INTER-OFFICE MEMO

Item B.2: 7918-0373-00

Supplemental Information: Page Replacements

RE: Development Application No. 7918-0373-00

SITE PLAN - 13048 13 AVE

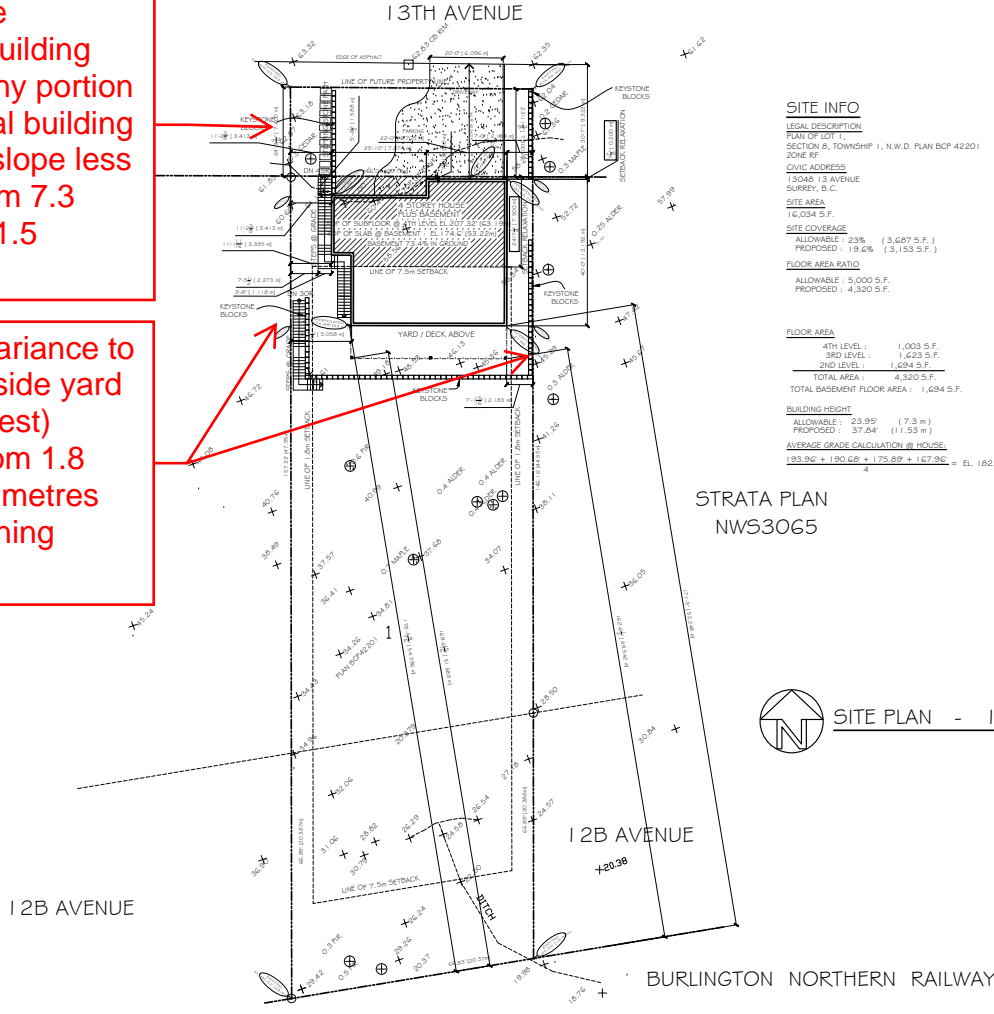
Proposed variance to increase the maximum building height for any portion of a principal building with a roof slope less than 1:4 from 7.3 metres to 11.5 metres.

Proposed variance to reduce the side yard (east and west) setbacks from 1.8 metres to 0 metres for the retaining walls.

SCHEDULE B

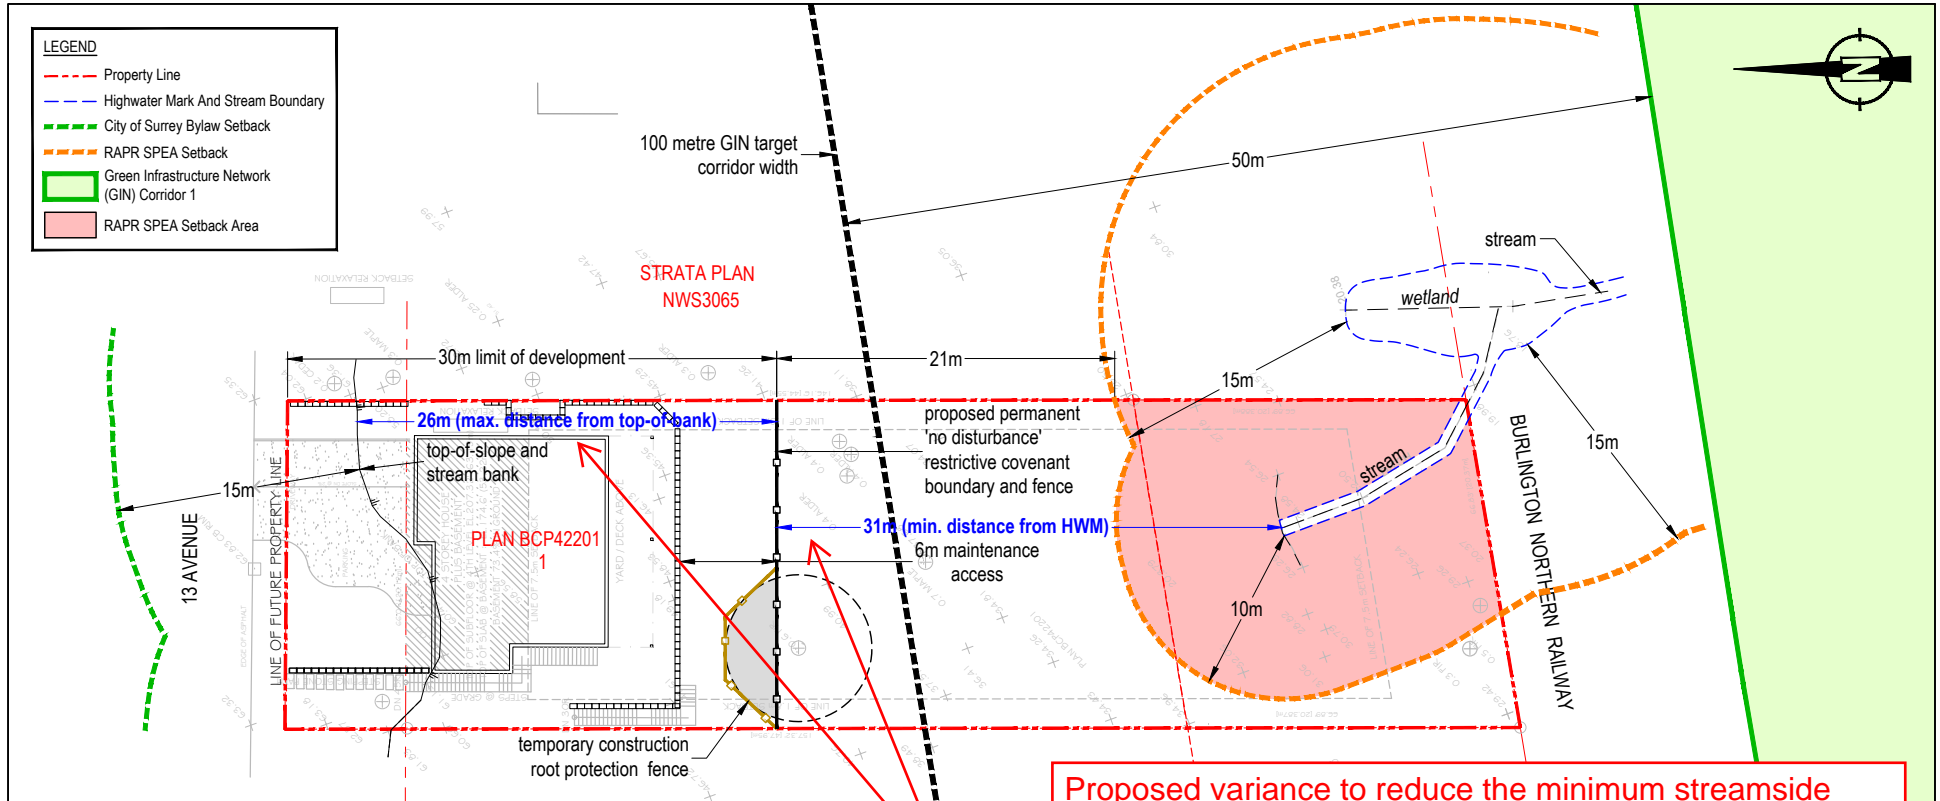
Proposed variance to reduce the minimum streamside setback from a Natural Class B Stream on a lot of record from 15 metres, as measured from top-of-bank, to a minimum of 31 metres from the high water mark (equivalent to 26 metres below the top-of-bank).
